ATTENTION – Requires immediate attention! General Issue

Part and Feature: [REDACTED]

Tool: Two-flute carbide drill [REDACTED]

Problem: Hole runout

Figure 1. Failed tool and its tool tag

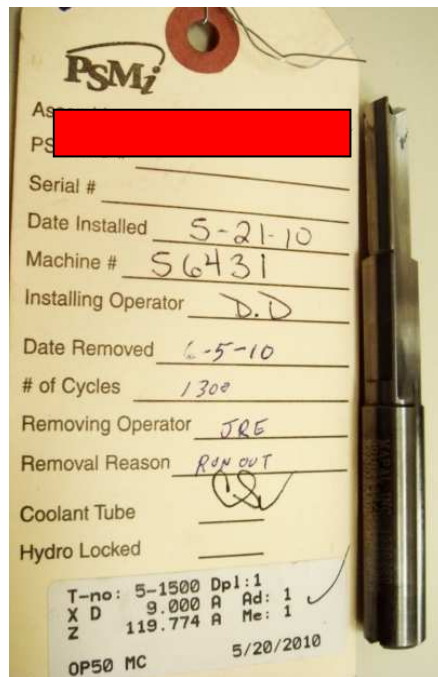
Figure 1 shows the failed tool and its tool tag. The tool is new. As can be seen, the tool ran 1,300 cycles. The tool life set for this tool is 1,500 cycles, i.e., the tool almost made the tool life. Further investigation shows that if the tool is used for standard D or C variants, it drills 15 holes per cycle, for B – 6 holes, if for DuraMax – 19 holes per cycle although the tool life is set the same for all variants. Moreover, it is a tap drill, i.e., it directly affects the performance (tool life included) of the tap that follows.

Figure 2. Excessive wear of the tool drilling part

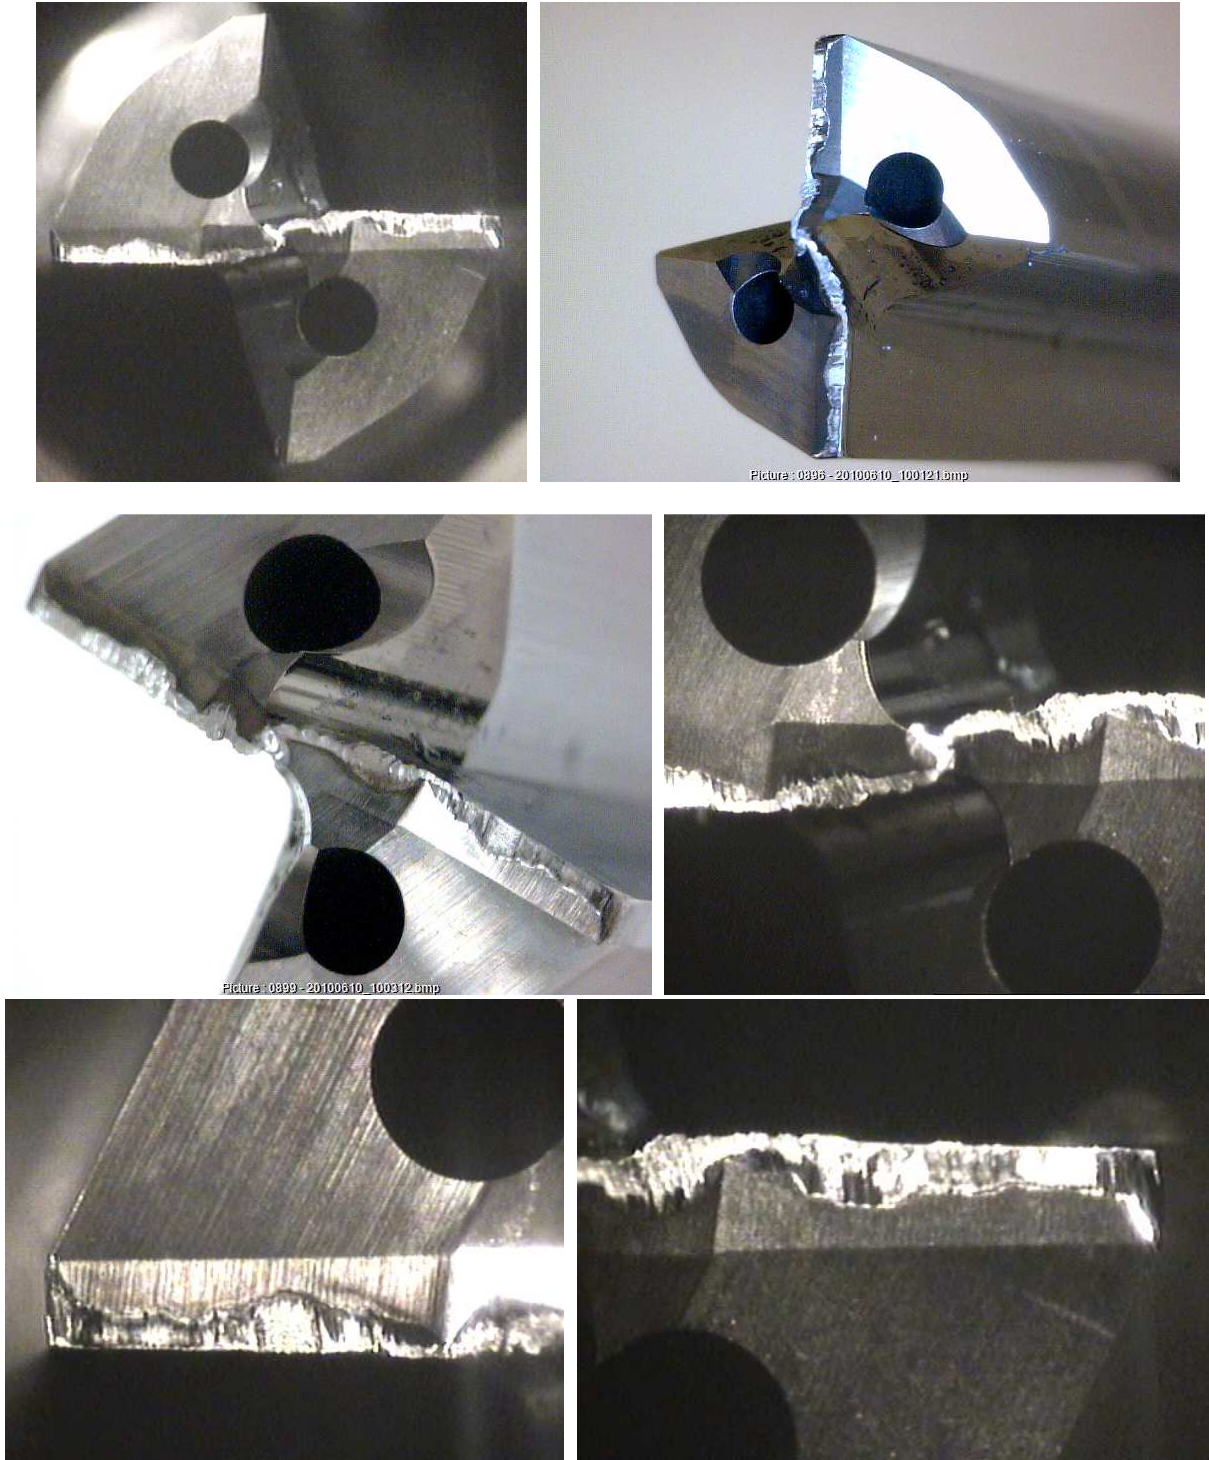
Figure 2 shows excessive wear of the drilling part of the tool. In my opinion, the tool with this amount of wear is not capable of producing decent tap holes. As a result, the tap that follows this tool will definitely suffer, and thus may produce “tight” threaded holes or may even break. In other words, the tool is a way overrun.

1. NEVER use coolant slots on the shank
2. Re-design drill for this application. It should be standard (not brad as it is now) point PCD drill

Figure 3. Small wear of the chamfering part

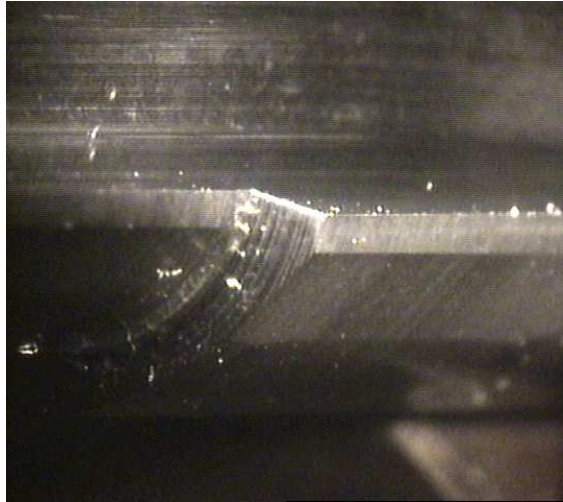
Figure 3 shows the chamfering part of the tool. As see, very small wear is seen there.
